Marrickville Council Submission – M4 East Environmental Impact Statement

This submission responds to the M4 East EIS, currently on public exhibition, and evaluates the justification for the current project (as part of the broader WestConnex project) as well as the mitigation and management measures proposed and the level to which the identified impacts of the project have been addressed.

FIGURE 4 VOLUME CAPACITY RATIO 2026 (PROJECT STAGE 1 & 2)

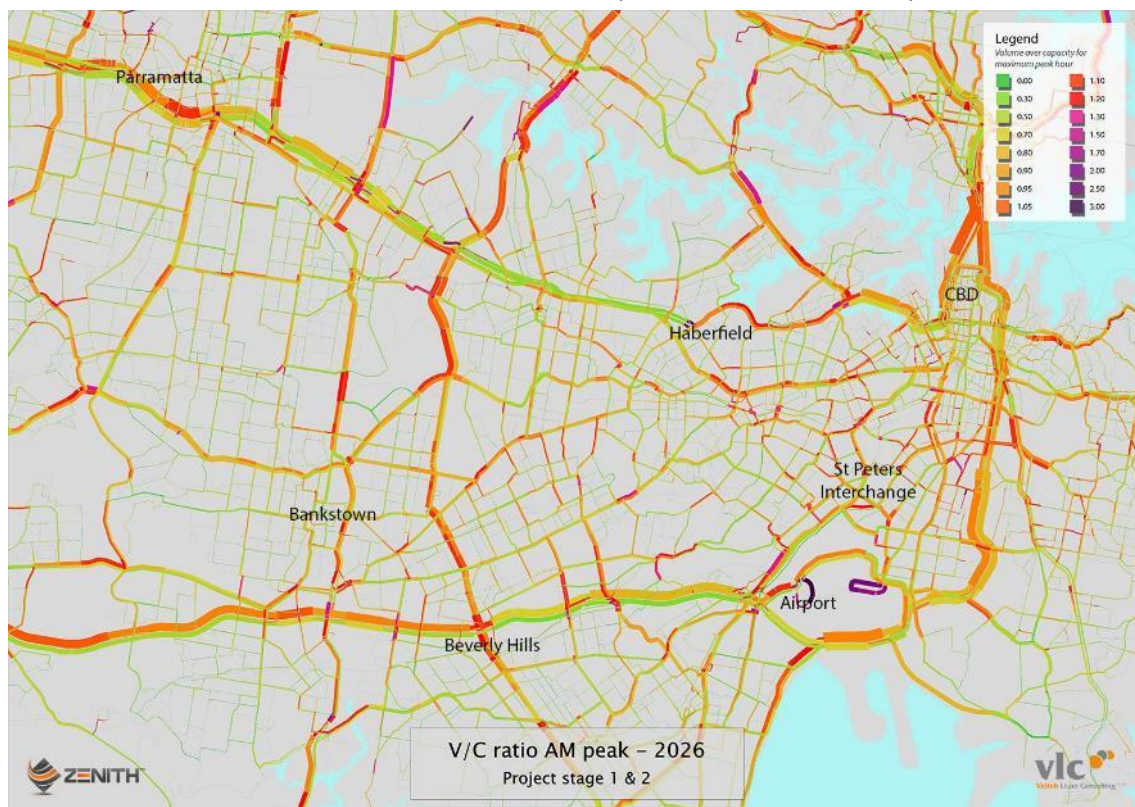
Also any adverse impacts from the M4 East's opening in 2021 are not assessed by the M4 East EIS. **The** M4 East is only evaluated post 2021 in combination with other WestConnex sections. There are risks that the M4 East will generate additional traffic (see Figure 5) that will only be addressed by other sections of WestConnex.

FIGURE 5 CHANGE IN VOLUMES 2026 (STAGE 1 & 2 VS BASE)

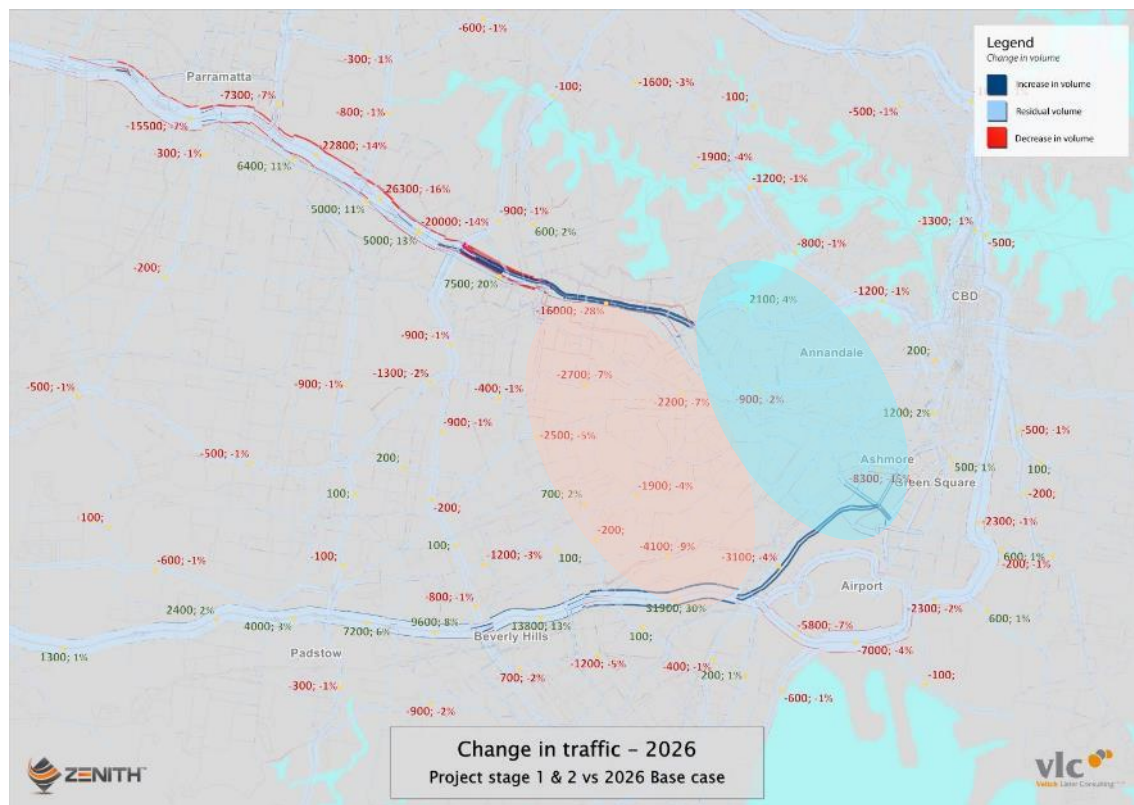
The M4 East EIS has not addressed the risks in terms of the traffic and socioeconomic impact of the project. Figure 5 provides an example of impacts which are not being considered by the EIS. Figure 5 shows the change in traffic volumes if only WestConnex Stage 1 and 2 are operational.

WestConnex Stage 1 and 2 create two distinct corridors on the local network (highlighted in Figure 5):

- the first one (in red) where the traffic volumes generally decrease by a small amount;
- the second one (in light blue), between Haberfield and St Peters precincts, where volumes generally increase.

There are risks that EIS should have identified around increased surface road traffic (and associated amenity and possible business impacts) which could result if Stage 3 of WestConnex is not completed at the same time as the M4 East.

FIGURE 7 WESTCONNEX CATCHMENT 2026 (PROJECT STAGE 1 & 2)

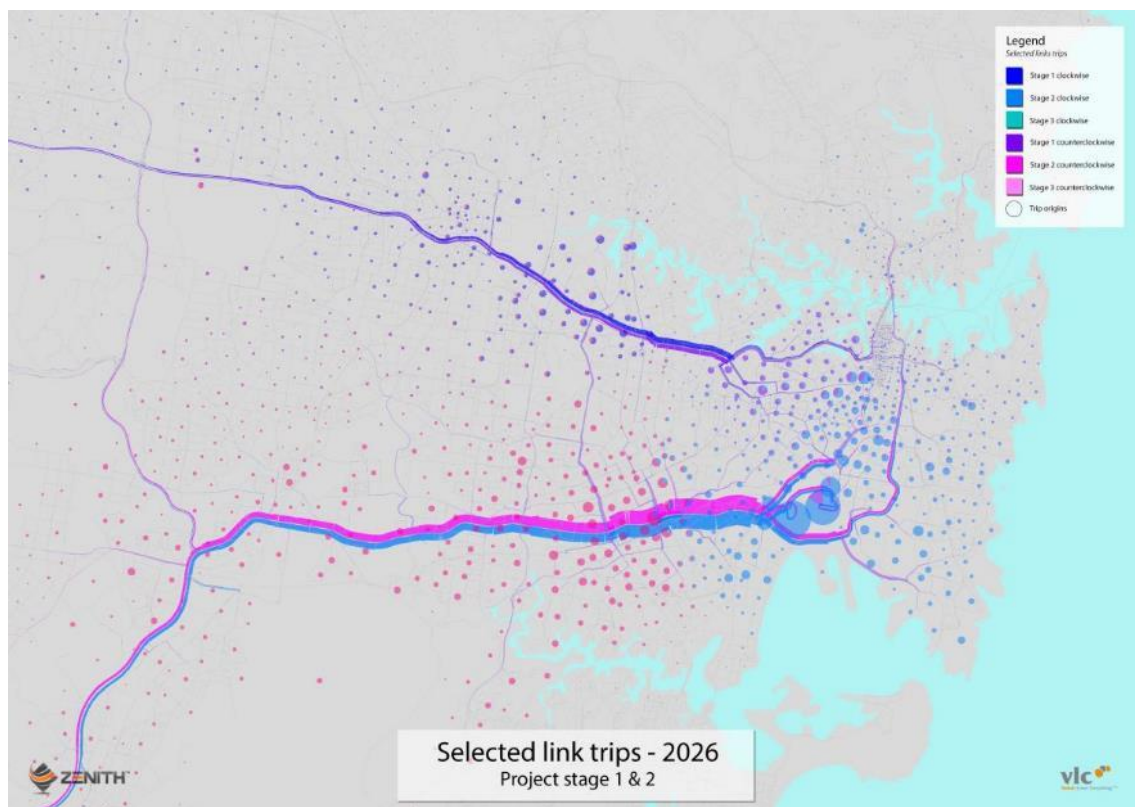
For example, Figure 7 shows the WestConnex volumes and trip origins in the M4 East (Stage 1) and New M5 (Stage 2). Within the figures the bandwidths show the expected routes of WestConnex users, from where their trip originates to their final destination.

Figure 7 makes it clear that Stages 1 and 2 serve different markets. Stage 1 provides access to Parramatta and Haberfield, with vehicles at the end of Stage 1 at Frederick Street dispersing across the local network. Stage 2 serves mainly Sydney airport, Green Square and other eastern suburbs.

This analysis highlights that there are risk from the project to other parts of Sydney road network which are not being considered by the EIS.

FIGURE 8 SYDNEY'S POPULATION GROWTH FORECAST (2011–2031)

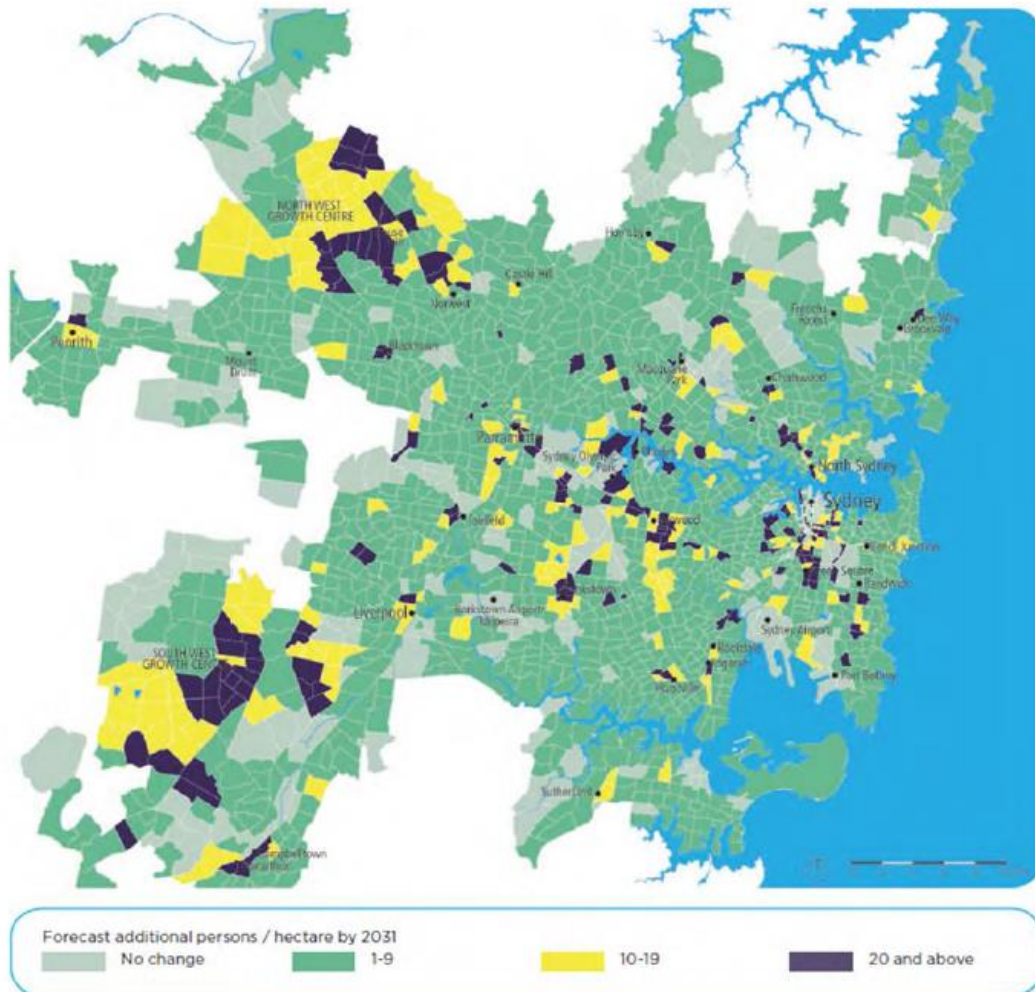
But the standard land use projections shown in Figure 8 indicate that there would clearly be implications for travel demand along the Parramatta Road Corridor and M4 East if there were an additional 70,000 residents⁵ along Parramatta Road. Assessing this project risk should have been part of the M4 EIS.

FIGURE 9 COMPARISON OF DO NOTHING AND PROJECT CASE FOR 2031

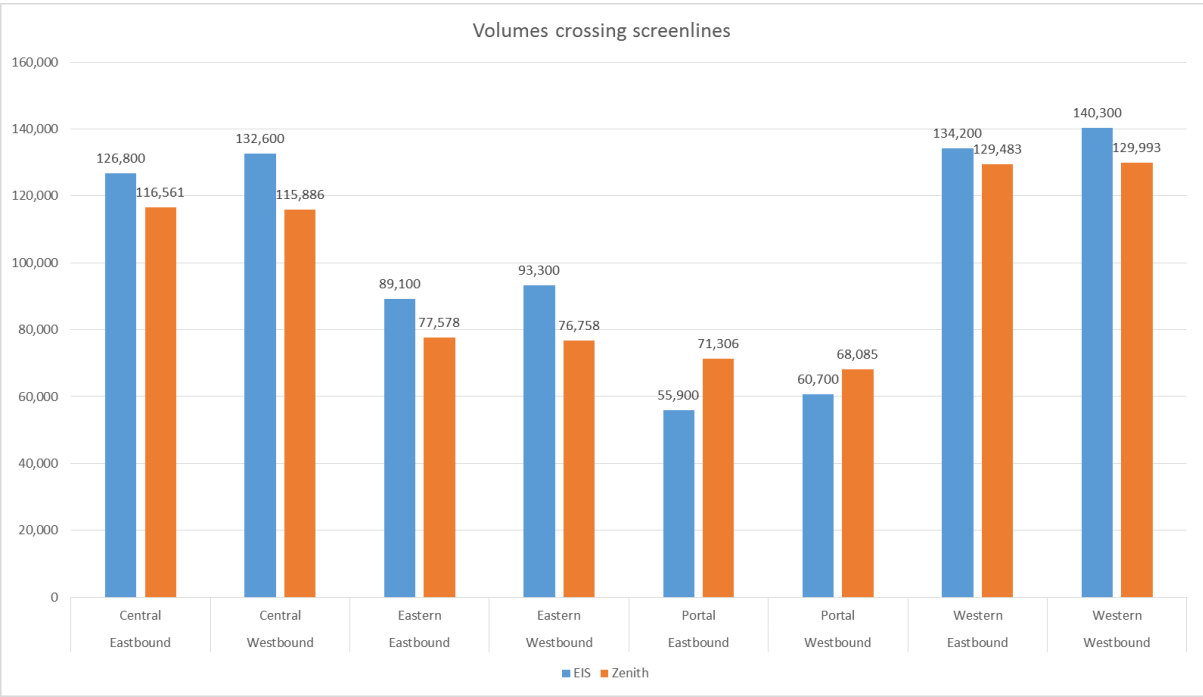
The figure below compares the volumes across the four screenlines out of the two models. The two sets of results are very similar. The figure below can be compared to Figure 8.2 in the EIS document. It shows that the forecasts of diversions to the new road infrastructure are consistent.
